**FINAL DRAINAGE REPORT
FOR
STERLING RANCH FILING NO. 5**

**December 2023
Project No. 25188.16
PCD Filing No: XX-XXX**

**Prepared By:
JR Engineering, LLC
5475 Tech Center Drive, Suite 235
Colorado Springs, CO 80919
719-593-2593**

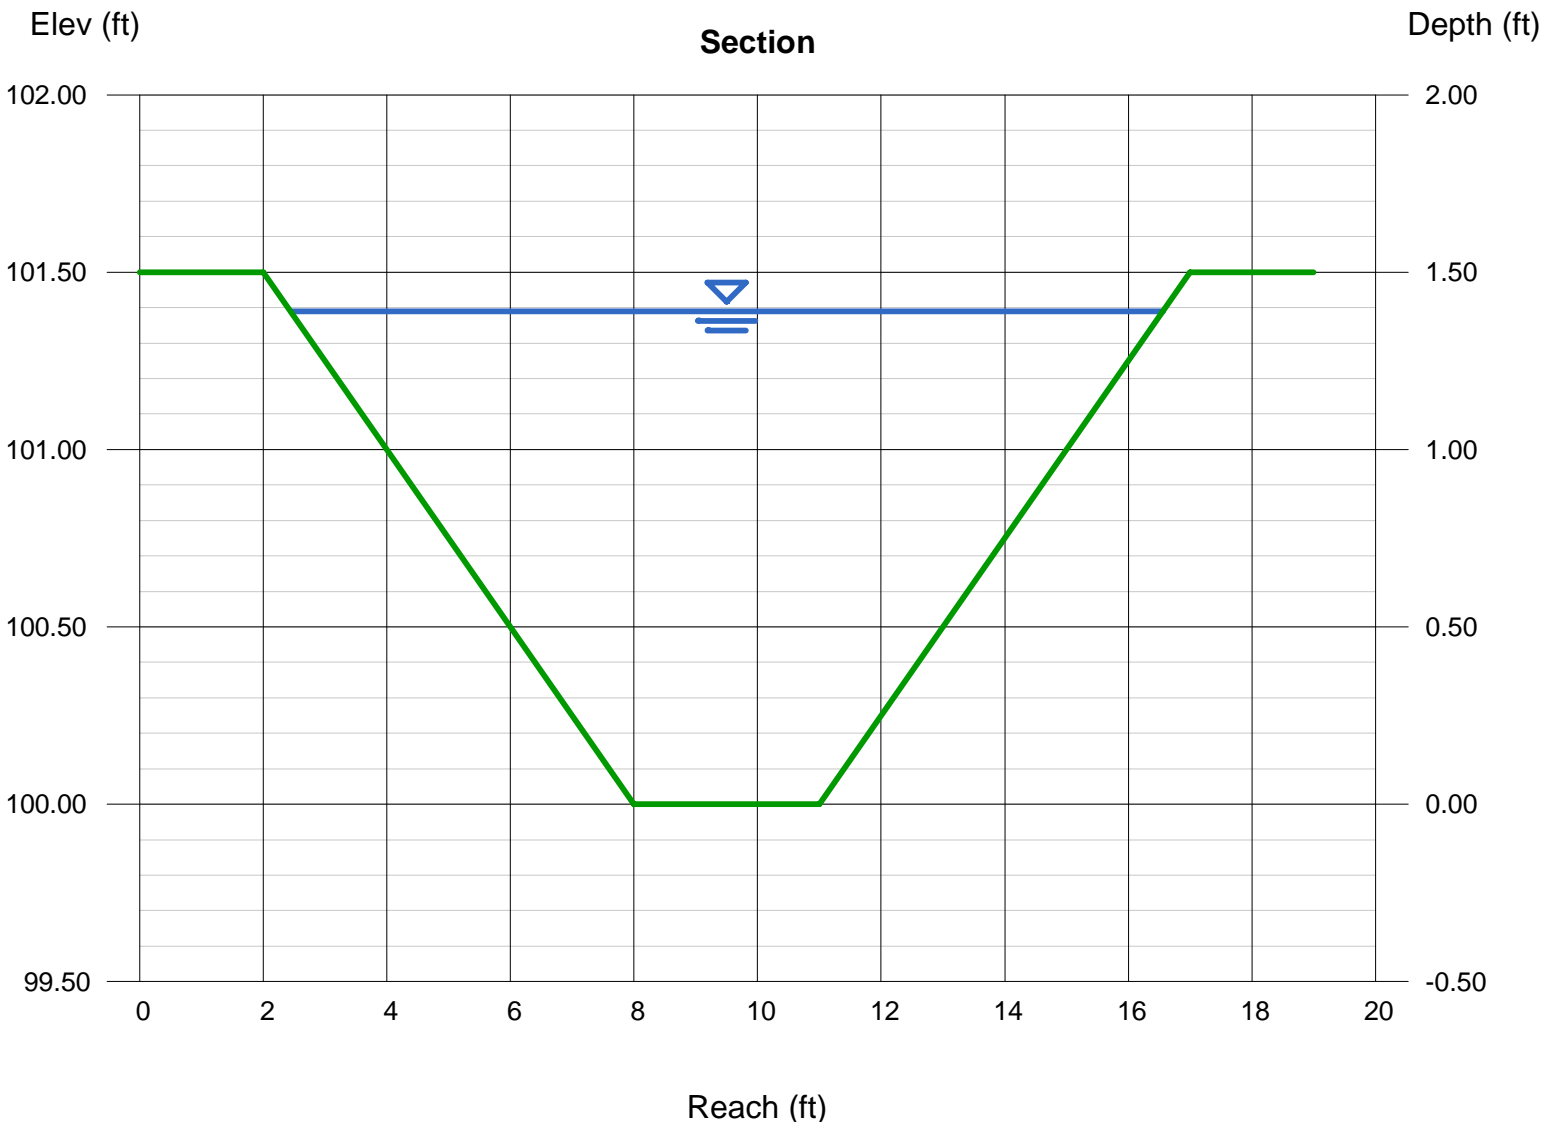
Provide calculation for DP2 emergency overflow swale

JR Response: Created section for existing swale

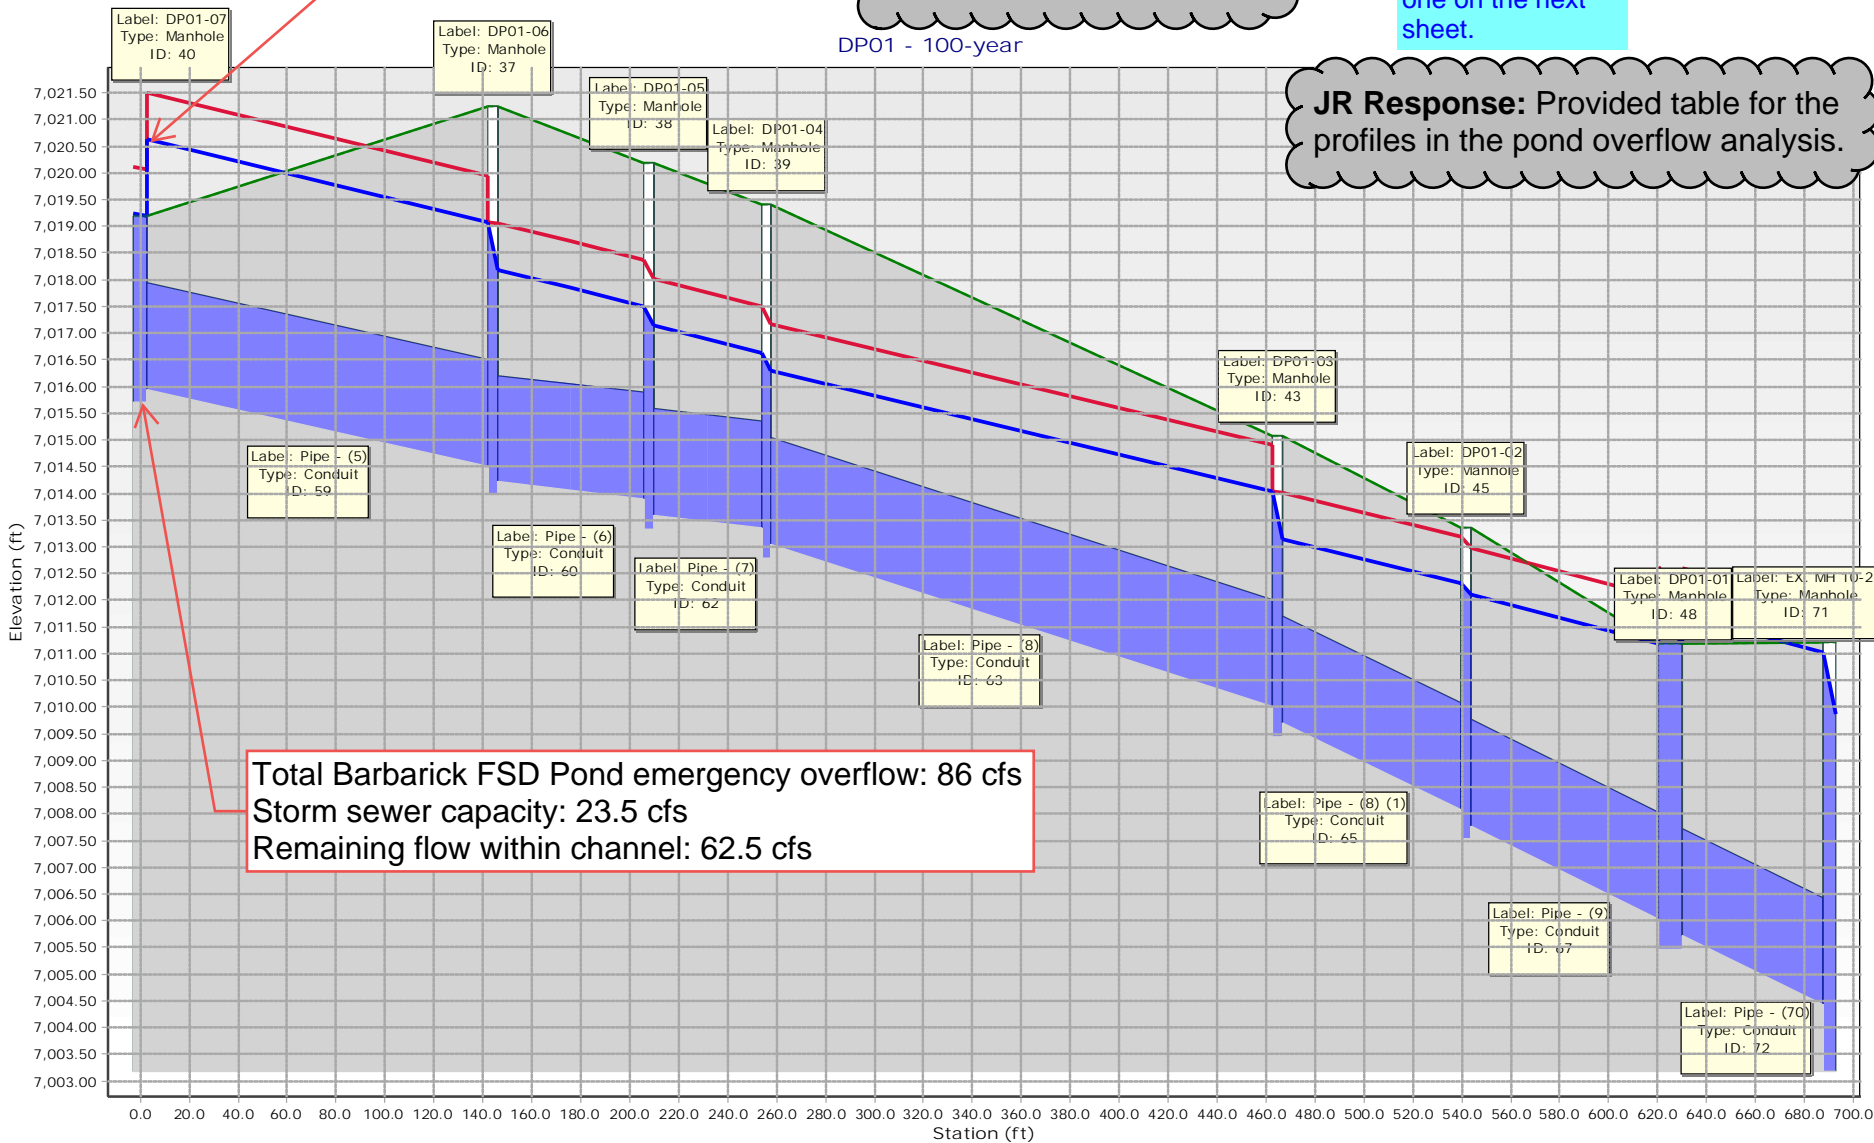
Show HGL elevations around inlets to show flows remain with int channel

Provide StormCAD tables that correspond to this profile and the one on the next sheet.

JR Response: Addressed.

JR Response: Provided table for the profiles in the pond overflow analysis.

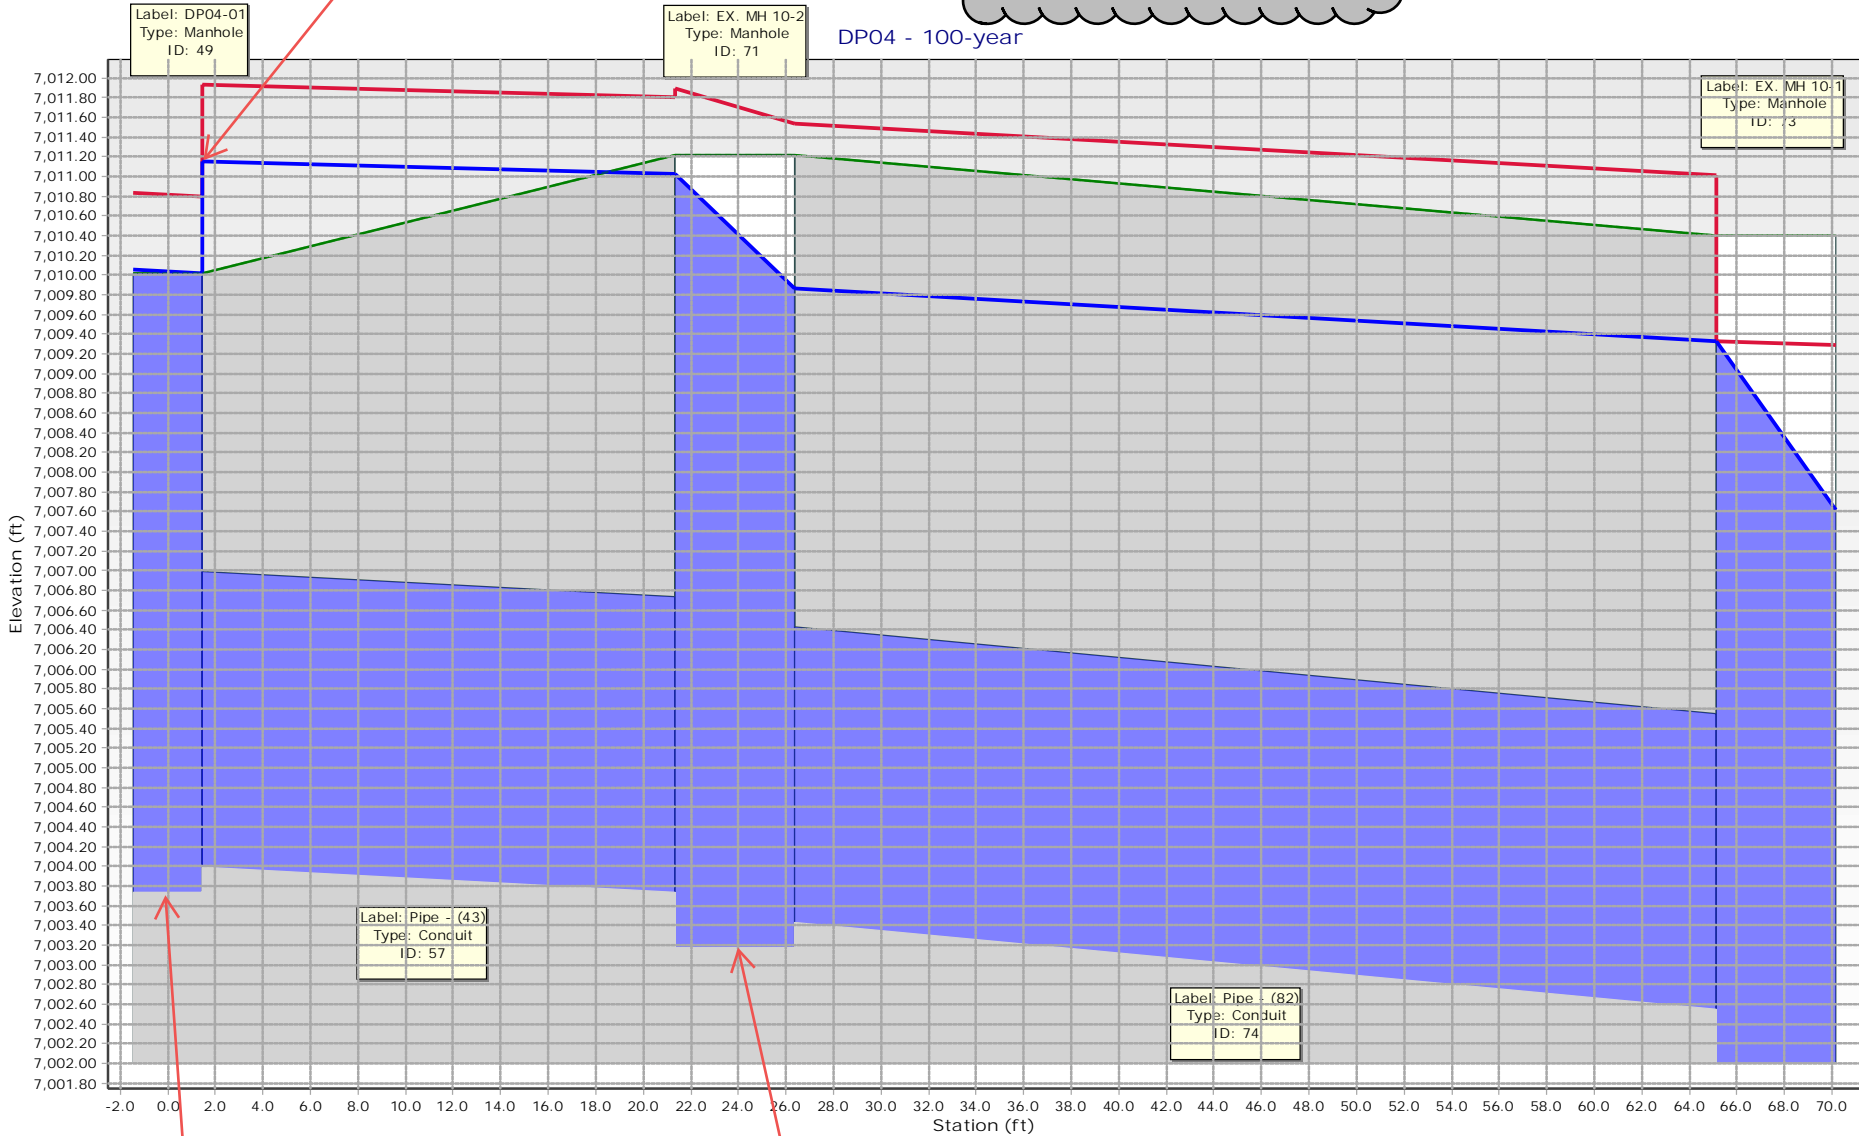
Show HGL elevations around inlets to show flows remain with int channel

JR Response: Addressed.

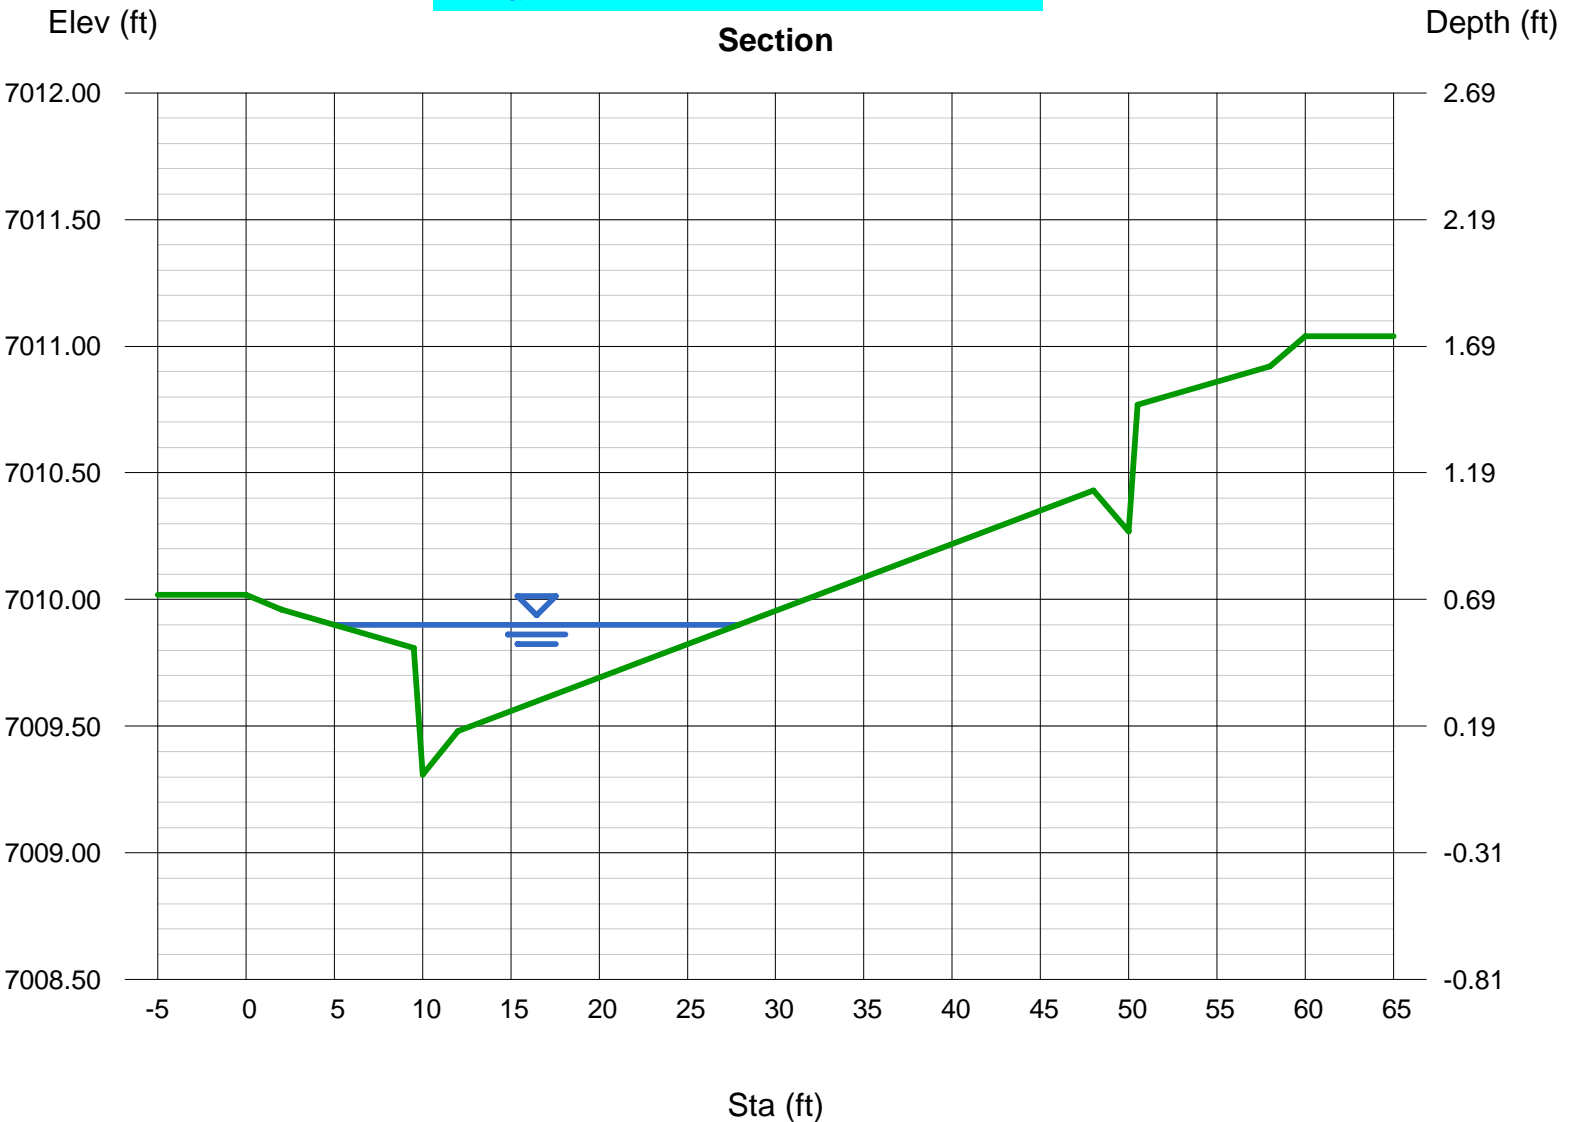
Provide an additional analysis for flow of at least 17.5 cfs (Flow from DP 8 & emergency flows from DP3 & DP5). Worse case scenario would also include emergency flows from Barbarick Pond & DP 1 & 2.

JR Response: Created emergency overflow exhibits for the pond emergency overflow and the inlet emergency overflow. Went into more detail on calculations for how the flows were determined for both scenarios.
